PROJECT MANAGER FOR LaCrosse  
SEP SECTION LEADER D. Allison  
TECHNICAL REVIEWER R. Schott

REQUEST FOR ADDITIONAL INFORMATION ON SEP TOPIC VII-3 SAFE SHUTDOWN

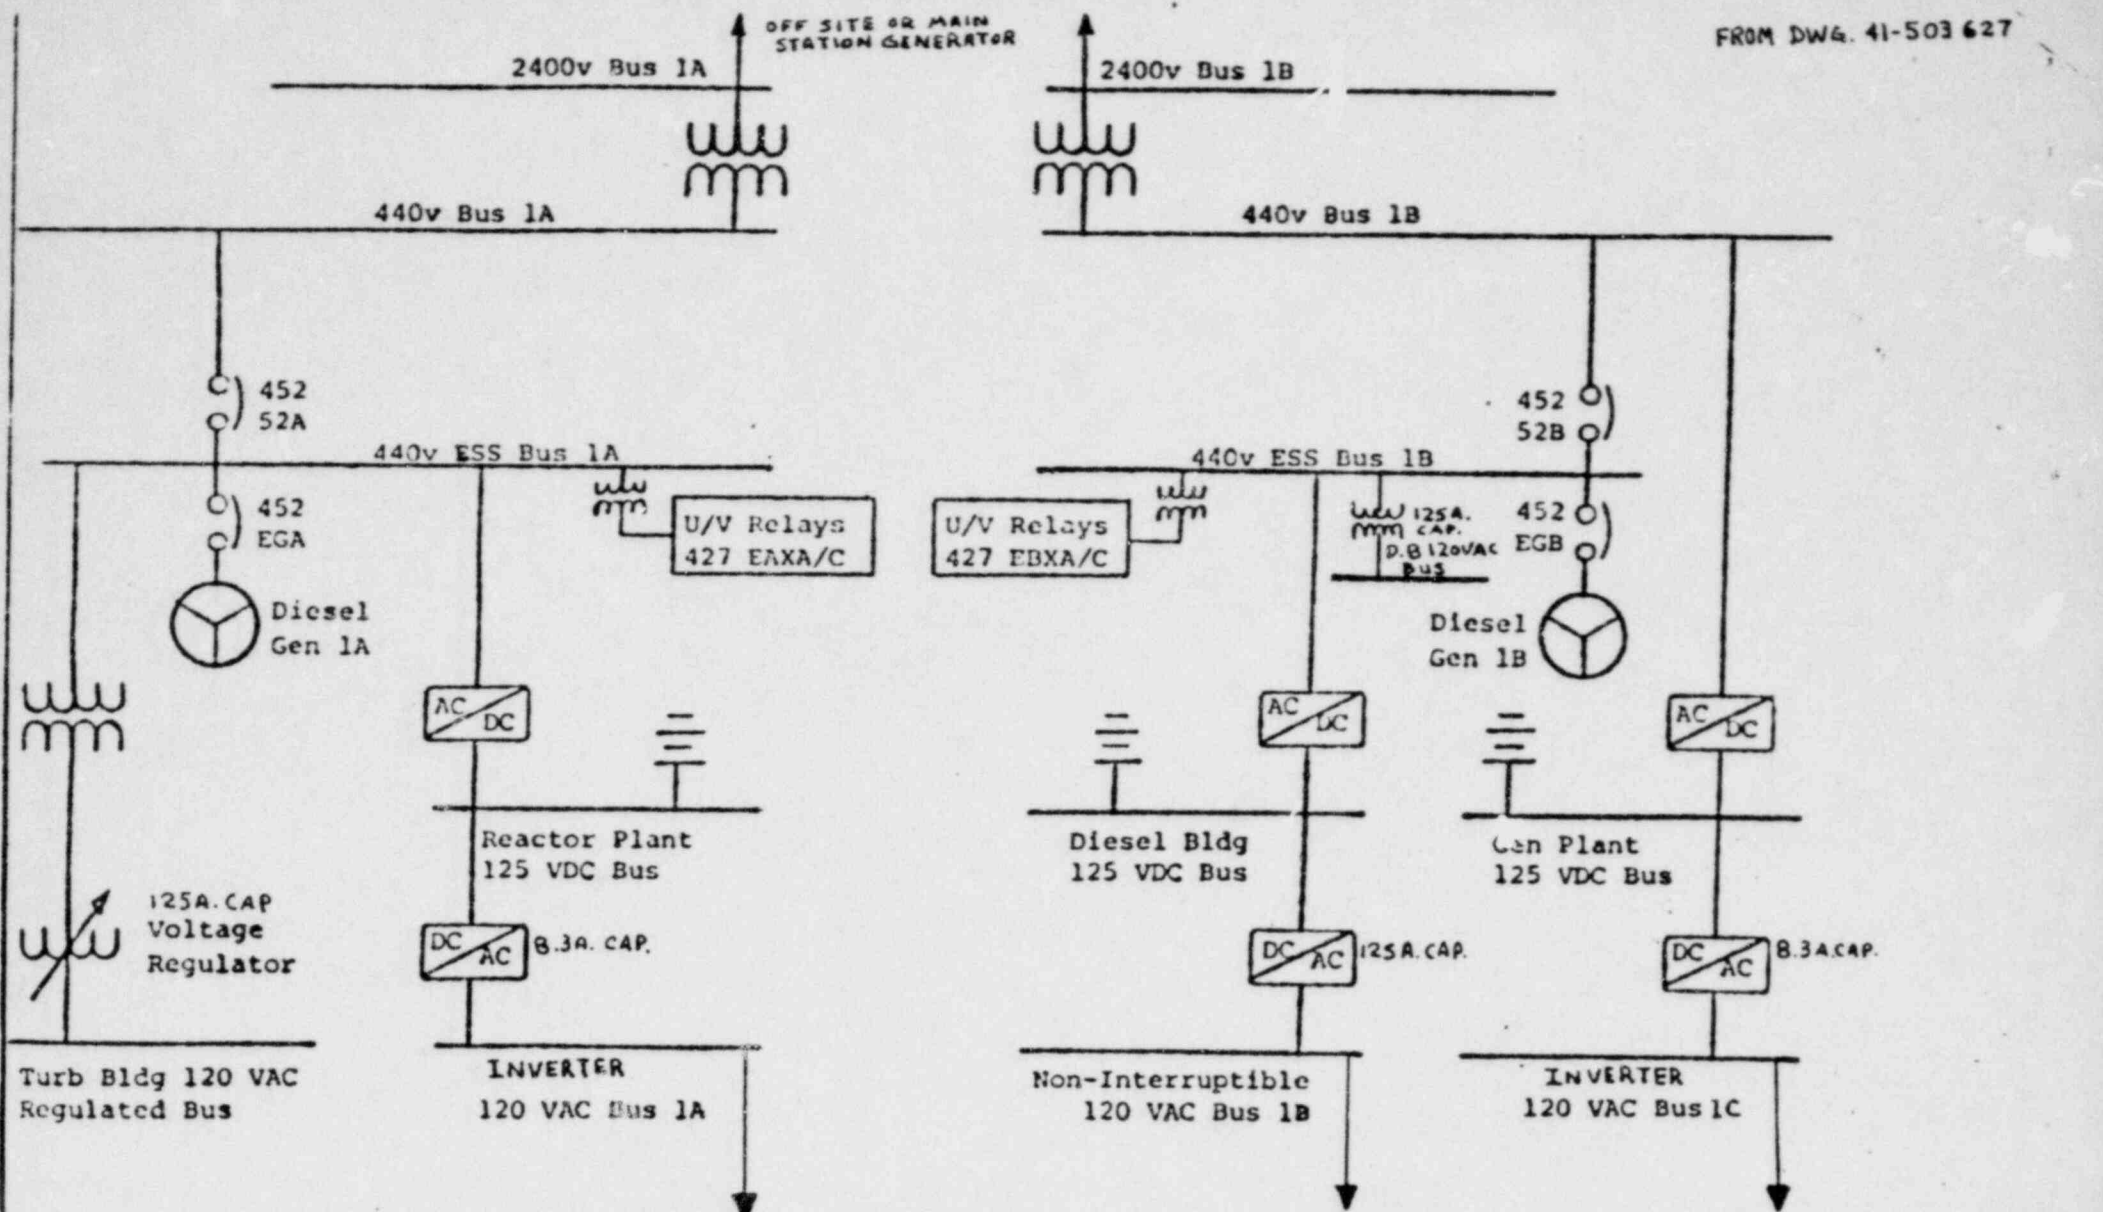
1. P&ID for High Pressure Service Water, Low Pressure Service Water
2. Control Diagrams for Valves 60-25-003, 60-25-007, 64-30-001, 64-25-001, 50-25-002
3. Control Diagram for Pump 56-06-001
4. Power supplies for temperature, pressure, level, and flow for safe shutdown systems either in table format or a key diagram showing which bus(es) supply which system(s) instruments.

1. CONT. Bldg PRESS 37-35-401
2. CONT. Bldg. Level 37-42-401
3. R<sub>w</sub> water Level XMTR 50-42-401
4. R<sub>w</sub> water Level ch II SAFETY SYS. 50-42-502

1. All other SAFETY Related Equip. (PRESS., Level, Flow, Temp.)
2. R<sub>w</sub> water Level ch I SAFETY SYS.
3. All other NON-SAFETY Related Equip.
4. Post accident MONITORING ch II

1. R<sub>w</sub> water Level XMTR ch II
